Subject: Duke Energy Carolinas, LLC (Duke)
McGuire Nuclear Station, Units 1 and 2
Docket Nos. 50-369 and 50-370

Response to Request for Additional Information related to
the License Amendment Request for Implementation of
Alternative Source Term.

Duke Response to Meteorological Data Quality Issues

SCALE 1" = 100'
DUKE POWER
MCGUIRE NUCLEAR STATION
PLOT PLAN FOR
CONTROL ROOM HABITABILITY
ASSESSMENT
FIGURE: 1

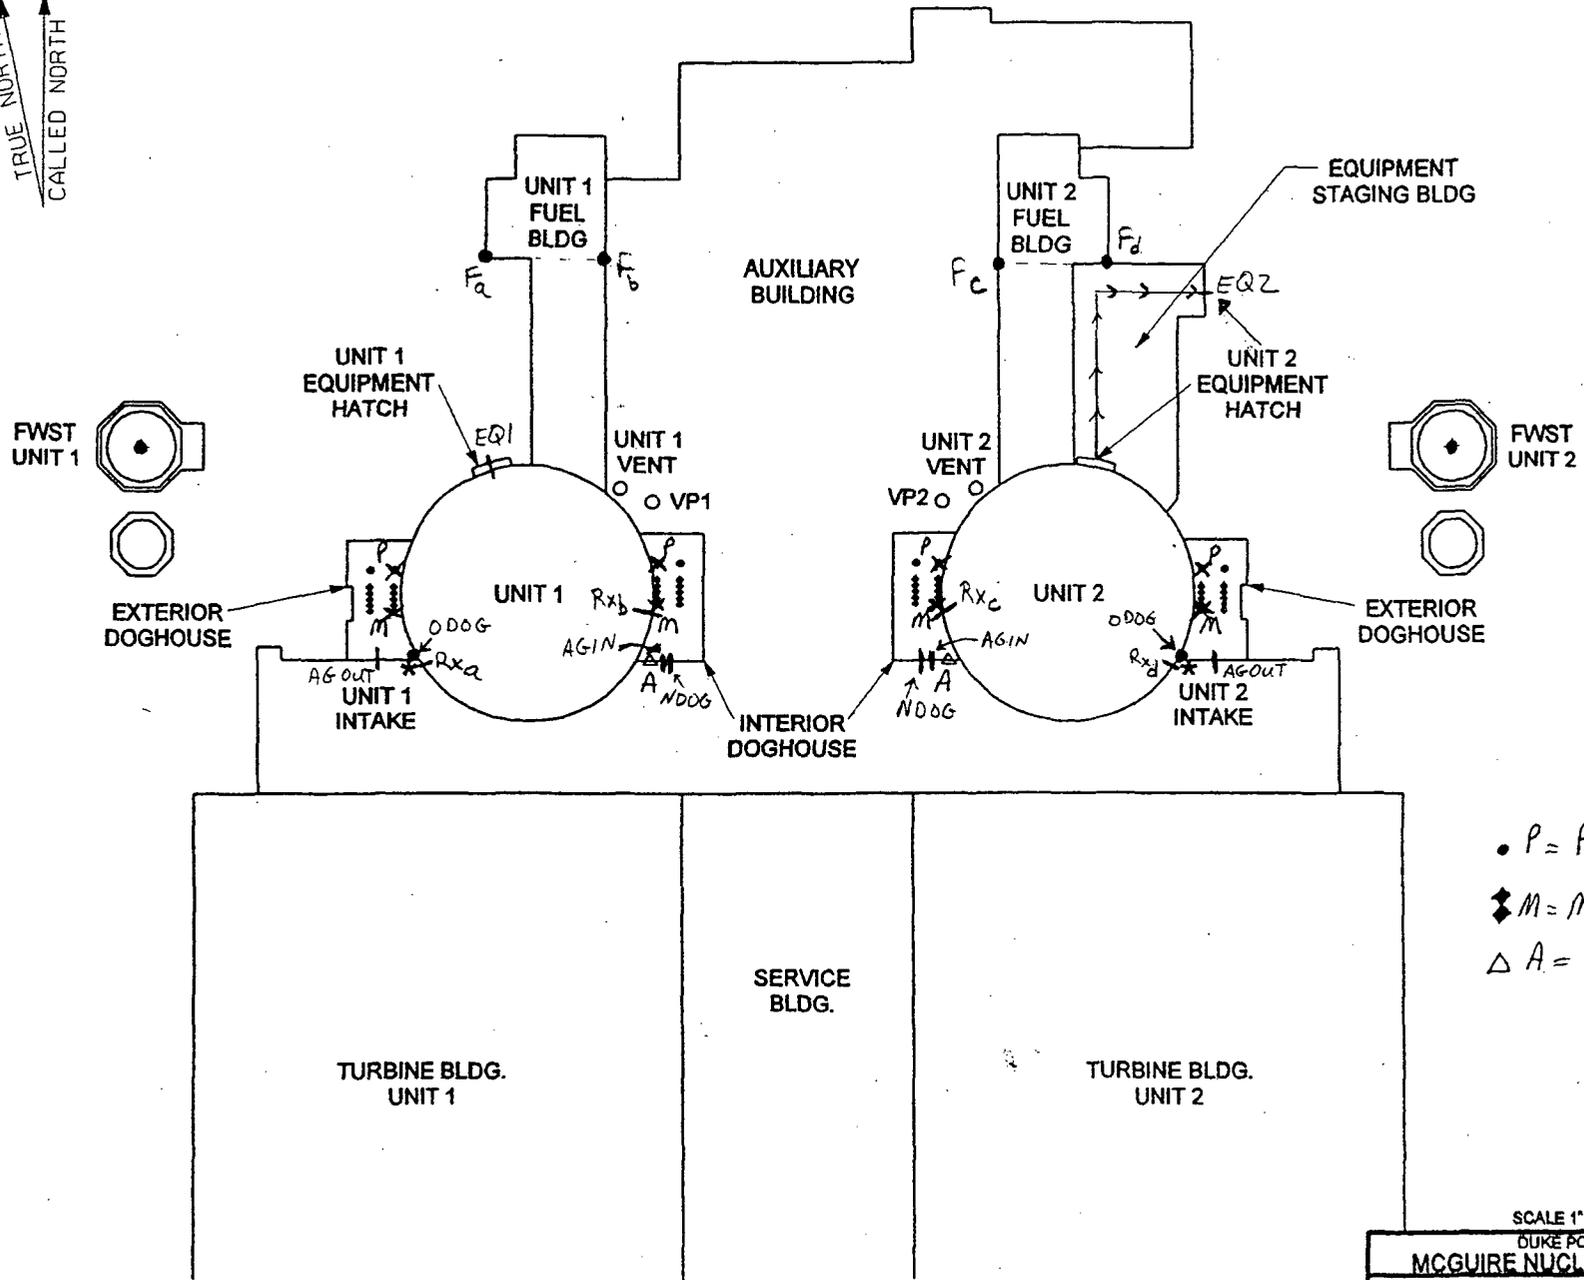
Is the Appendix A drawing of the March 20, 2008 LAR drawn to scale? If so, please provide the scale used for the drawing. Are all of the postulated release locations applicable to this LAR clearly highlighted to enable NRC staff to make confirmatory estimates of the selected inputs and assumptions? If not, please highlight all postulated release locations on a revised scale drawing and provide to NRC staff.

Yes, the plant sketch that was included in Appendix A to the original LAR submittal (Reference 2) was drawn to scale (originally 1"=100 ft), but it is not an "engineering drawing." Also, the figure supplied with the original LAR submittal (Reference 2) was not scanned to full original size so application of the scale to that sketch would not have been appropriate. Thus, both the original sketch and the marked-up version attached in Appendix B of this response should be treated as approximate, since they (a) are largely based on McGuire Nuclear Station "fly-over" data (Microstation format) with uncertainties inherent to aerial surveys, (b) have been reproduced by scanning and via copy machines, and (c) the updated sketch includes source locations plotted by hand. To verify the scale, note that the diameter of each reactor building (Unit 1 and Unit 2) is 130 feet.

Exact locations of all of the sources were not shown on the figure in Appendix A of the original LAR (Reference 2). A marked-up version of that sketch is included as Appendix B of this response. It should be used by applying the scaling to estimate distances. The locations of the all sources have been clarified on the sketch in Appendix B of this response package, as described below:
